ASSESSMENT REPORT

M2 SITE, NORTH RYDE SSD 5093 MOD 1

Figure 2: Northern part of M2 Site showing line of existing, approved and proposed gas main

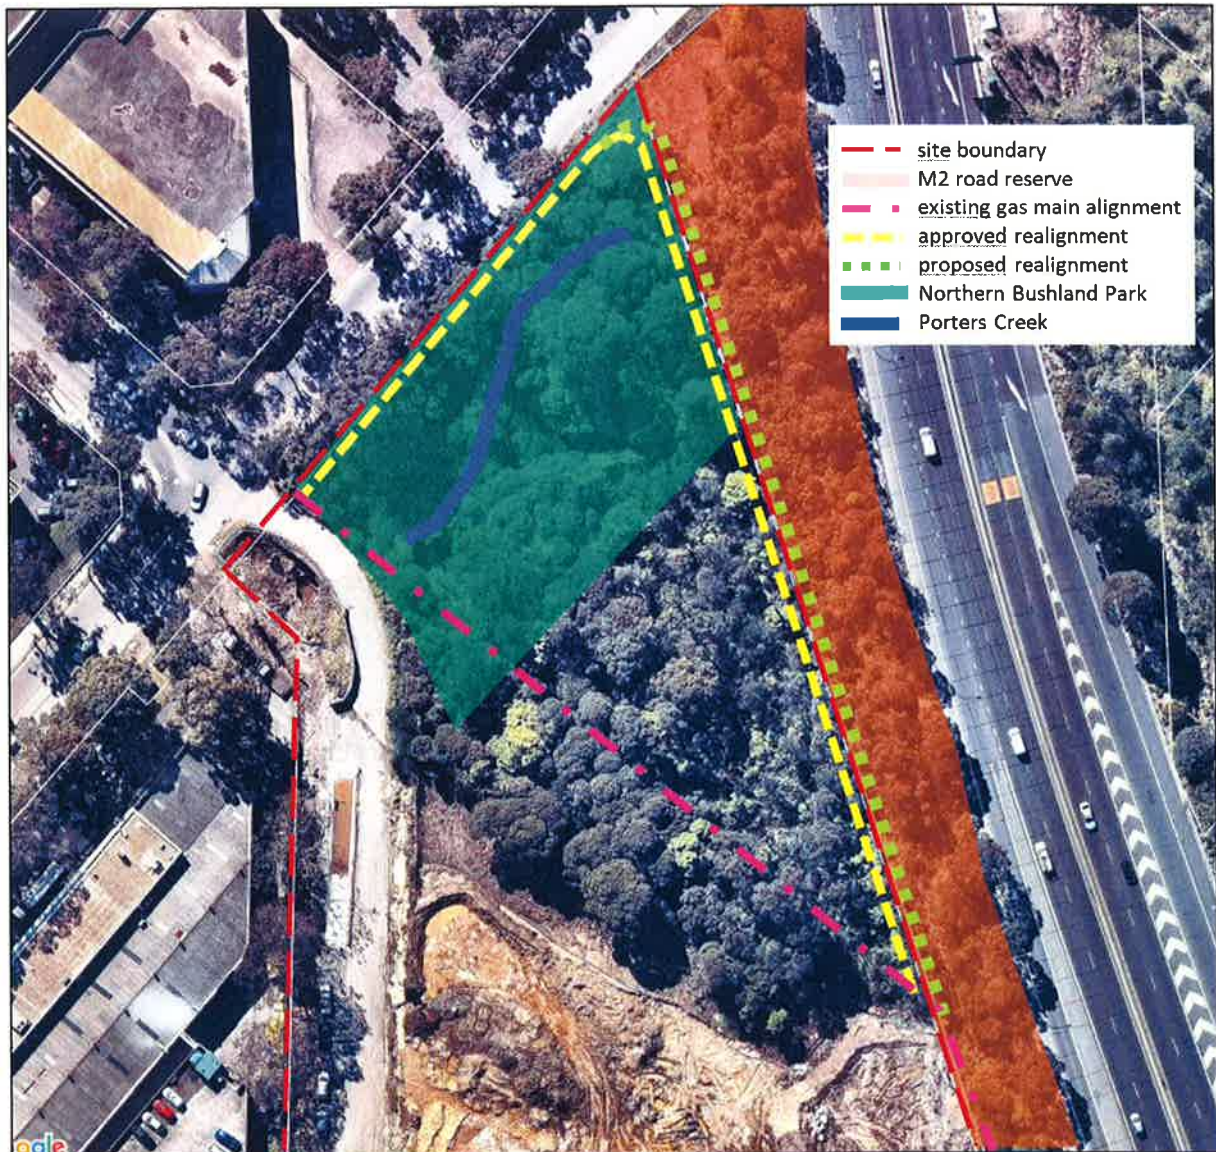
On 18 June 2015, the Proponent lodged a section 96(2) modification application (SSD 5093 MOD 1) seeking approval to amend the proposed location of the gas main, from inside the site running along the northern and eastern boundaries, to outside the site onto the adjoining RMS land and road reserve just outside the northern and eastern boundaries.

The modification application was subsequently revised, and now seeks approval to locate the gas main just outside the eastern boundary, but remaining inside the site along the northern boundary, as originally approved (refer **Figure 2**).

The modification essentially results in the relocation of impacts from just inside the eastern boundary to just outside the eastern boundary of the site (refer **Figure 2**).

Overall, the modification is likely to result in a net increase in tree removal from the area, as the land outside the boundary contains numerous trees which would otherwise be retained, while much of the area along the approved alignment inside the boundary is already approved to be cleared of trees for future construction. However, the proposed modification would also result in less trees being removed from the 'Northern Bushland Park', which forms part of the Porters Creek riparian zone (refer **Figure 2**).

Figure 4: proposed location of gas pipe relative to Porters Creek headwall and stormwater drain.

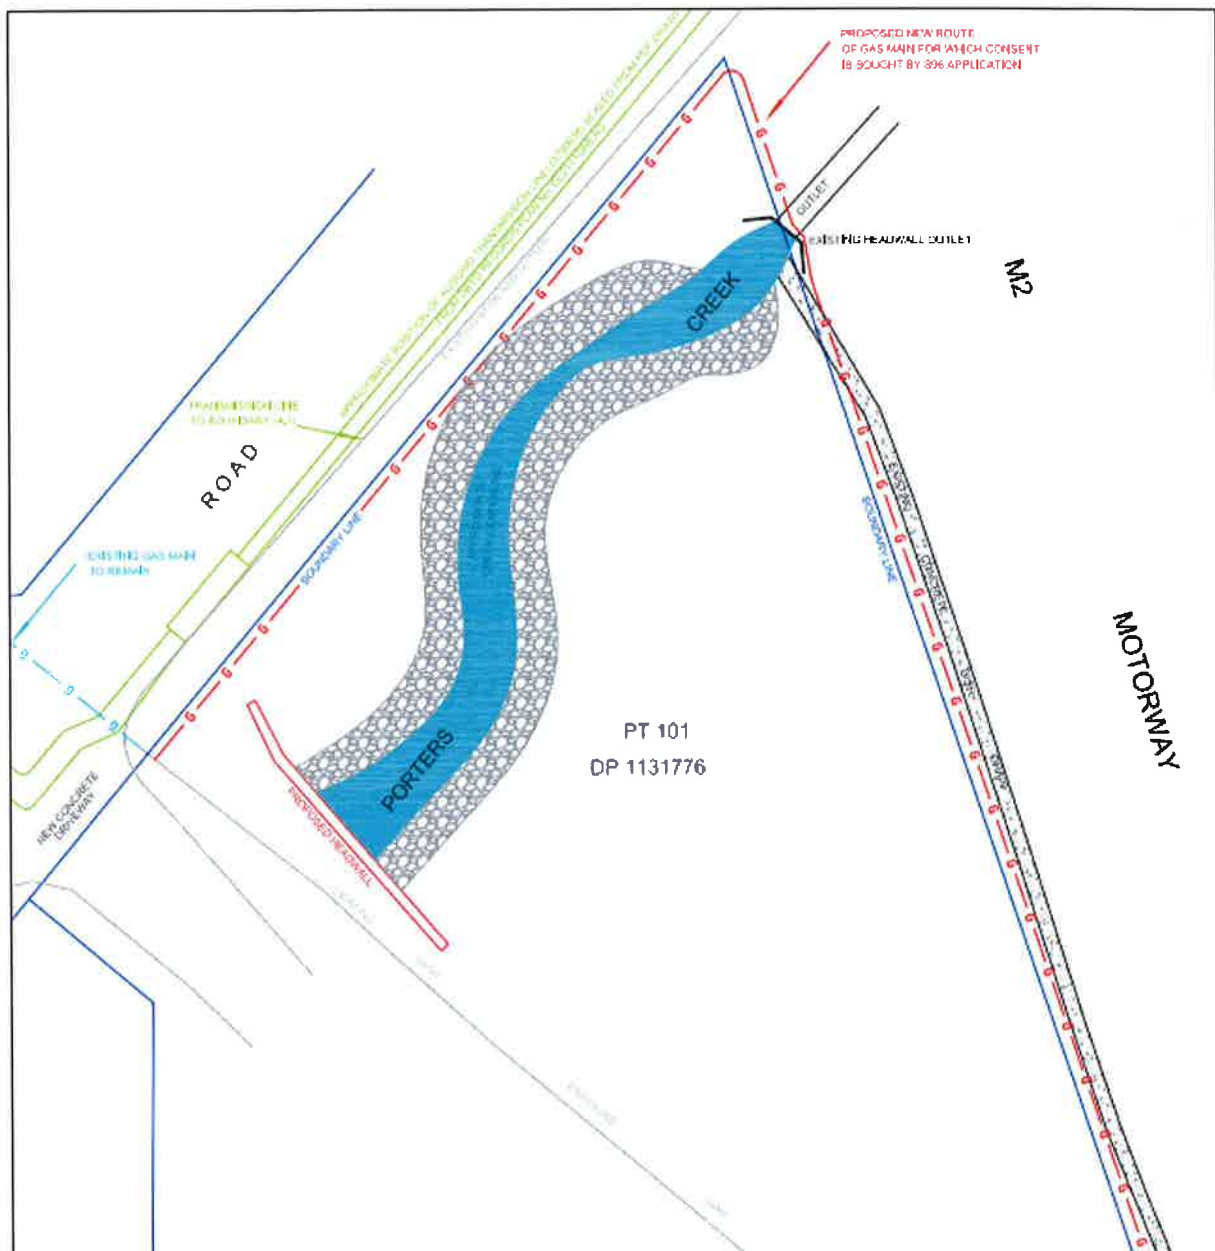
Department of Primary Industries, Office of Water (DPI) does not object to the modification, but sought clarification as to whether the gas pipeline would cross Porters Creek, and if so, whether there would be impacts to the riparian corridor.

In response to concerns raised in submissions about the impact of the realignment on Porters Creek, the applicant submitted additional details confirming that the gas main would not cross the creek, but would be located above the headwall of the creek (**Figure 4**). The gas main would cross the culvert in a concrete encasement on top of the existing headwall outlet.

As shown in **Figure 4**, the proposed pipeline would intersect with an open concrete drain which diverts stormwater runoff from the M2 Motorway to Porters Creek. Concerns were raised regarding the impact of construction on the drain.

As described above in **Section 6.1**, Ausgrid's concerns in relation to potential impacts on electricity cables located in Wicks Road (shown in green on **Figure 4**) have been resolved, as the applicant no longer proposes to run the pipeline along the Wicks Road road reserve (as was the original intention of the modification), but to maintain the approved alignment inside the northern boundary of the site.

In response to DPI's concerns, the applicant submitted additional information to demonstrate that the pipeline would not cross the creek, but would be located above the headwall (refer to discussion in **Section 7.2**). DPI advise it supports this approach.

The Department considers that the proposed modification results in an improved outcome compared to the approved alignment, which located the crossing to the west of the outlet, traversing through Porters Creek. This would have required temporary disturbance of the creek and creek bank stabilisation to construct a trench and pipeline underneath the waterway. The proposed modification allows the gas pipeline to be relocated without any disturbance to the creek bed or banks.

The applicant advises that where the drain intersects with the proposed pipeline, it would be demolished and reinstated to its former condition following installation of the pipeline. As the drain is a basic structure with no separate foundations or reinforcing, it is considered to be a

simple process to demolish and reinstate it to its former condition. In the interim, routine sediment and erosion control measures, which are required by existing conditions of consent, would be maintained.

A condition has been also recommended to ensure the proper reinstatement of the drain. On this basis, the Department is satisfied that the proposal would adequately manage impacts to existing infrastructure on the M2 site.
